Access Compliance Report

Public Rights-of-Way

(Curb Ramps)

Intersection ID: 46805	Main Street: ARBOR_CREST_CT	Cross Street: RED_BIRCH_DR	Location: W
ADA ID: 7612E26B7895	Ramp Type: PerpDiag	Initial Pass/Fail: Fail	Overall Compliance: No
Severity Score: 21.25			
Codes/Mitigation Info/Possible Solution		Field Measurements/Component Compliance

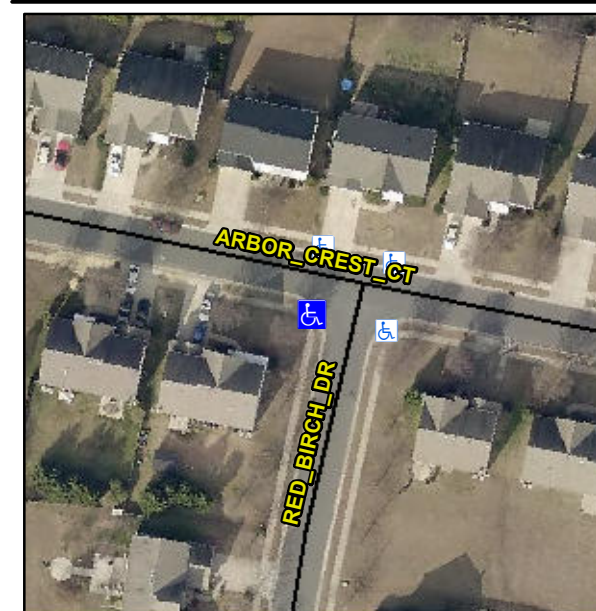
Not Found, R304.5.1, R304.5.3

Compliance	Description	Data	Compliance	Description	Data
N/A	Ramp Length (in)	49.0	Yes	Ramp Slope (%)	5.9
No	Ramp Width (in)	40.0	No	Ramp XSlope (%)	5.3
N/A	Flare Type LT	N/A	N/A	Flare Type RT	N/A
N/A	Flare Slope LT (%)	N/A	N/A	Flare Slope RT (%)	N/A
N/A	Flare Traversable LT?	N/A	N/A	Flare Traversable RT?	N/A
N/A	Landing Length (in)	N/A	N/A	DWS Provided?	N/A
N/A	Landing Width (in)	N/A	N/A	DWS Contrast?	N/A
N/A	Landing Slope (%)	N/A	N/A	DWS Length (in)	N/A
N/A	Landing X Slope (%)	N/A	N/A	DWS Full Width?	N/A
N/A	Landing Curb? (Y/N)	N/A	N/A	DWS Offset (in)	N/A
N/A	Shared Landing?	N/A			
N/A	Gutter Ponding?	N/A	N/A	Gutter Slope (%)	N/A
N/A	Gutter Lip Ht (in)	N/A	N/A	Gutter X Slope (%)	N/A
N/A	Painted X Walk1?	No	N/A	Painted X Walk2?	No
	X Walk 1 Direction	To SE		X Walk 2 Direction	To NE
N/A	X Walk 1 Width (in)	N/A	N/A	X Walk 2 Width (in)	N/A
	X Walk 1 Slope (%)	0.4		X Walk 2 Slope (%)	4.4
	X Walk 1 X Slope (%)	4.5		X Walk 2 X Slope (%)	1.2

Remove & Replace Curb Ramp With Two New Directional Ramps or Equivalent.
